CITY OF ALBUQUERQUE

August 17, 2018

RE: **Montebello on Academy Renovation**
10500 Academy NE
Grading Plan Stamp Date: 6/25/18
Hydrology File: E21D028A

Based on the submittal received on 8/1/18, this project is cannot be approved until the following are corrected:

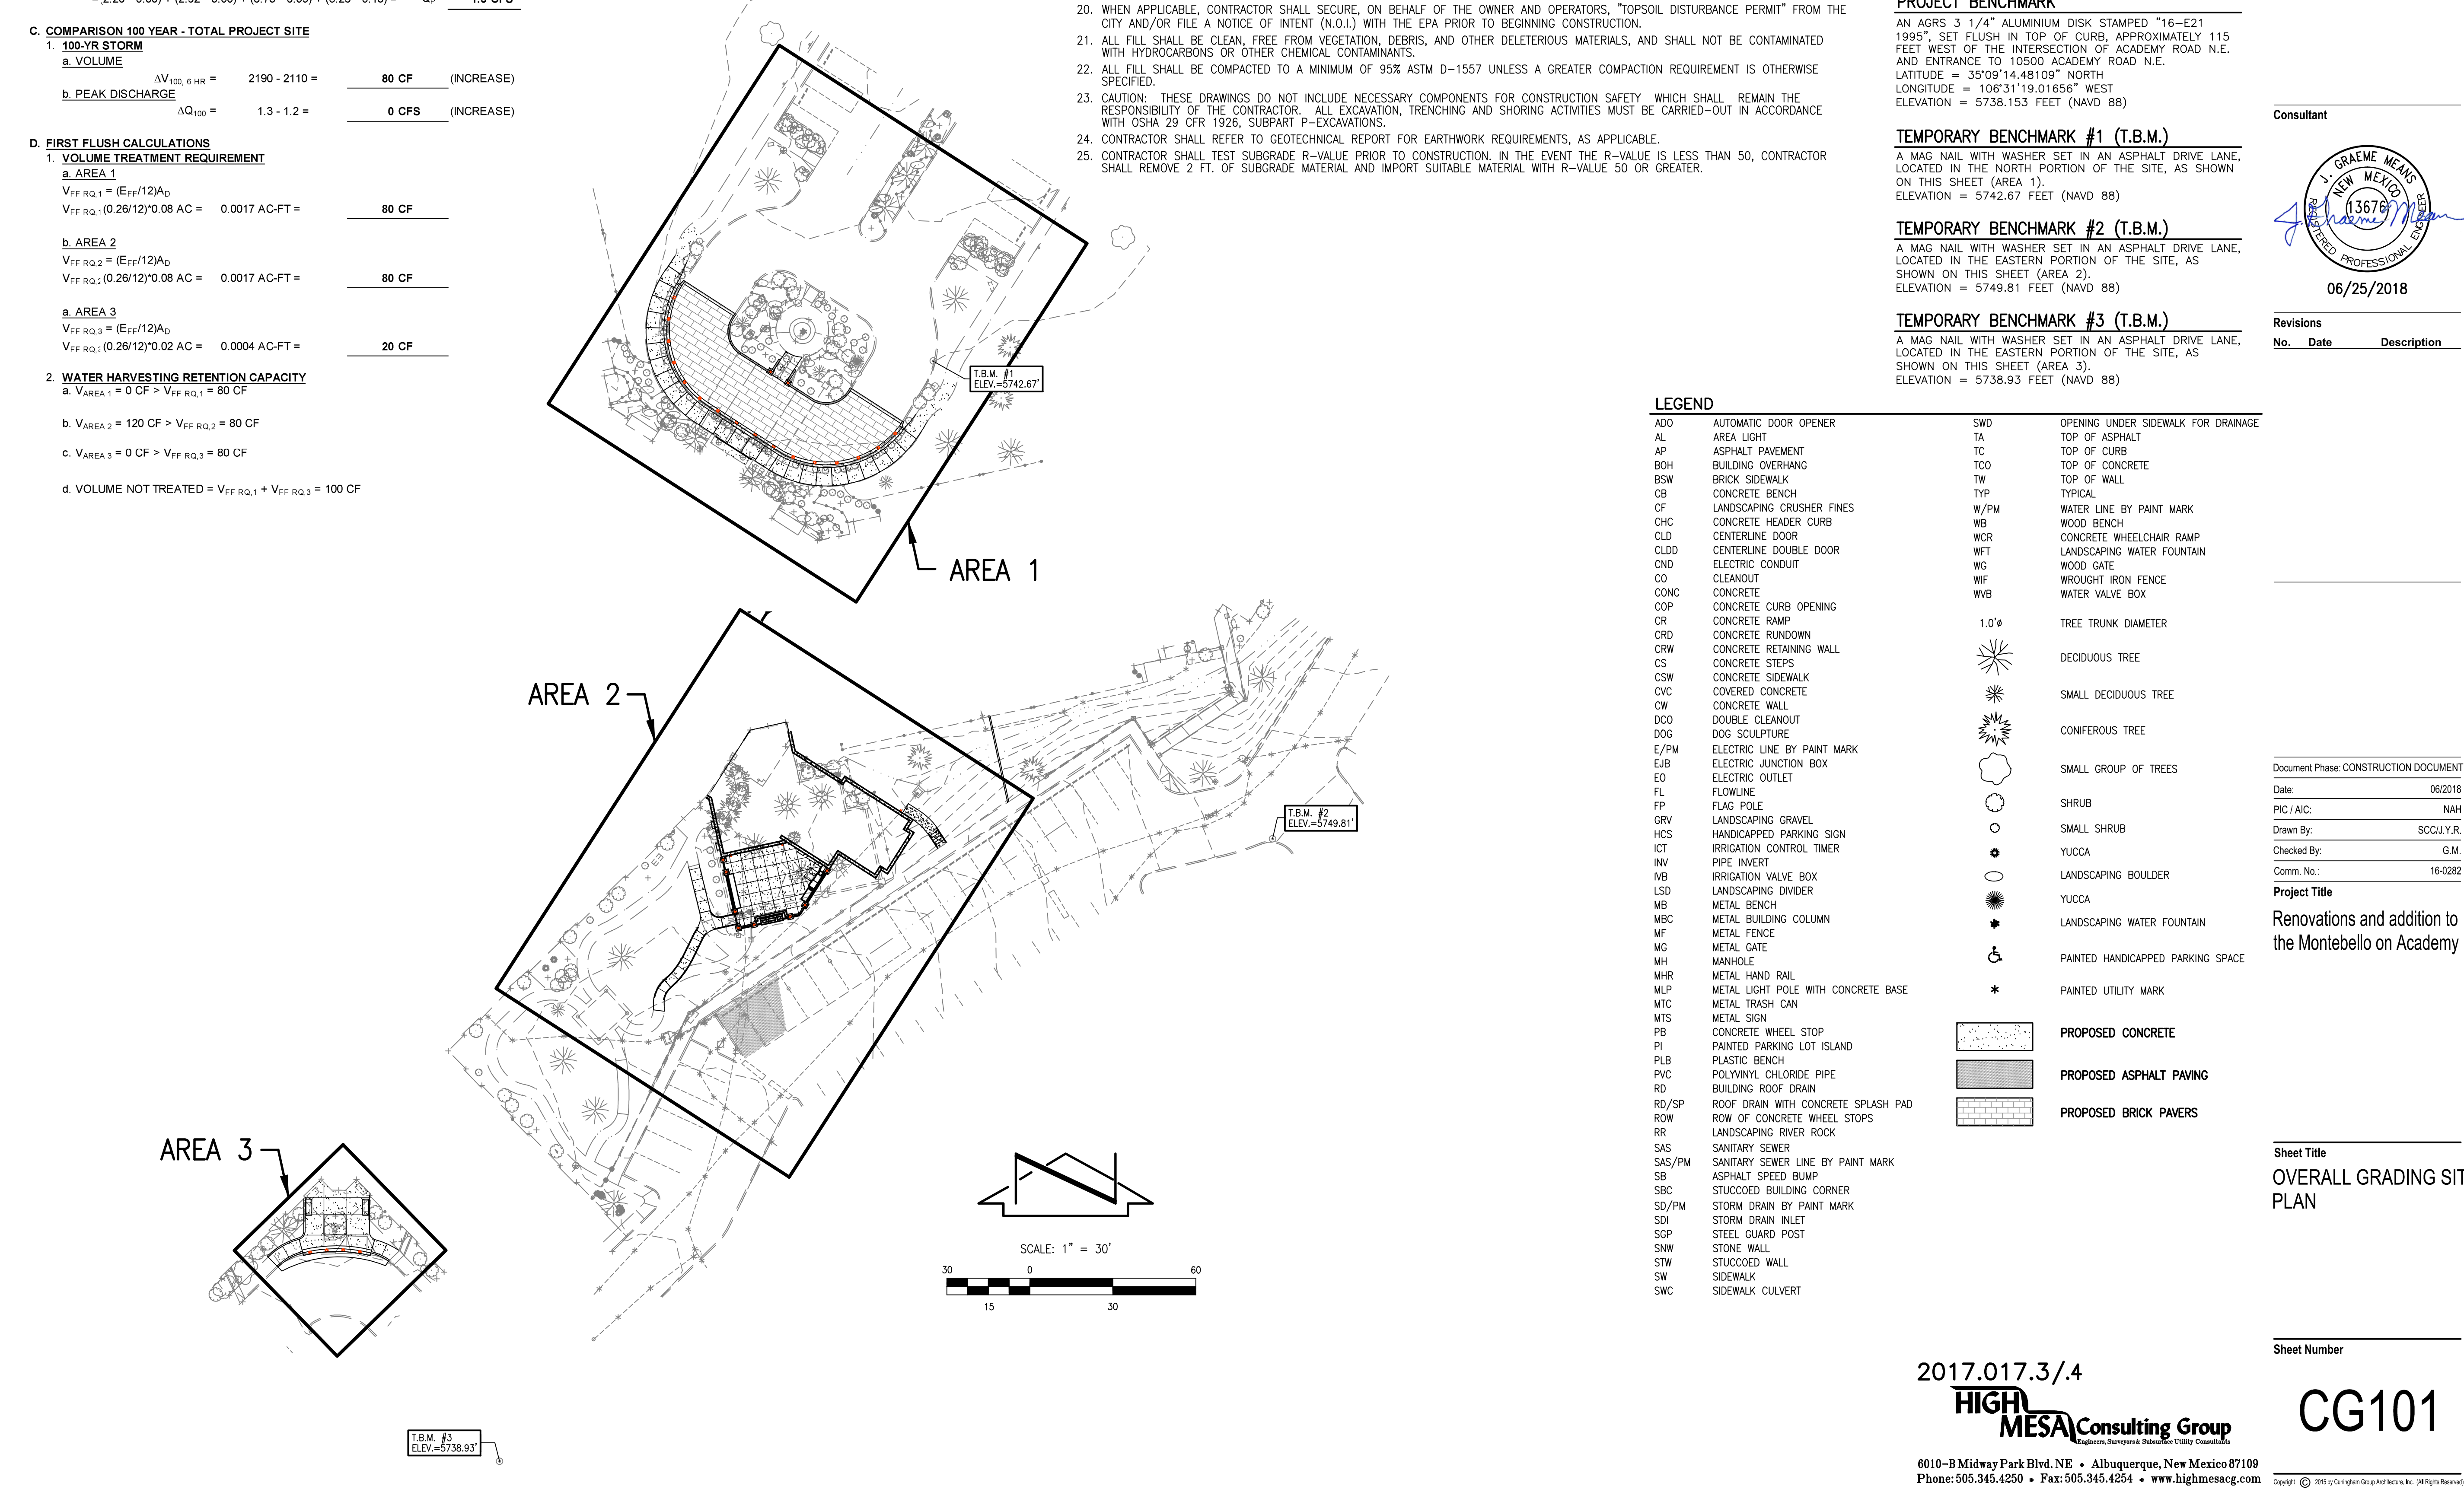
2. Payment of Fee-in-Lieu (Amount = 100cf x \$8/cf, per sheet CG101) is required. Include a copy of the 'paid' treasury deposit slip when resubmitting.
